MEMO

Re: Review of Minor Modifications to 109 S. Riverview Street

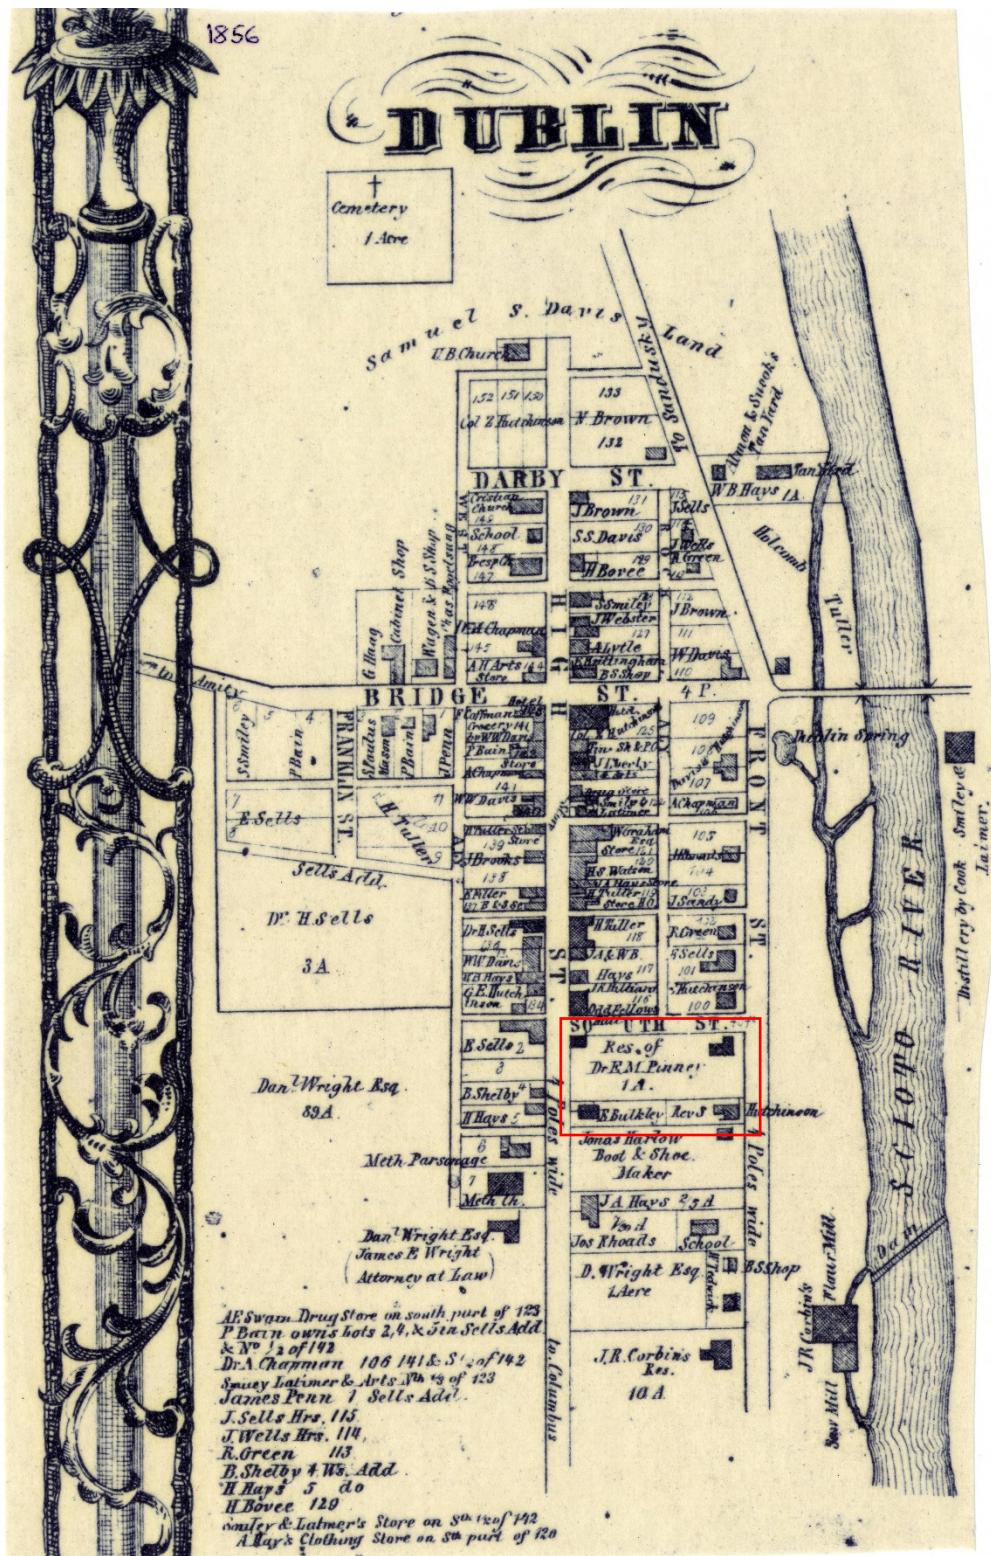
Historic wood trim is a character-defining feature of many of Dublin's historic buildings; it should be retained, patched, and/or repaired in kind in a sensitive manner. The property owner proposes to repair and rebuild existing soffits and gable end trims to match the existing ones on the historic building. It is important to note that the trim work on the north and south side of the historic home DO NOT match; this detail will be kept. Color will be an off-white to match the Pella windows.

APPROVED
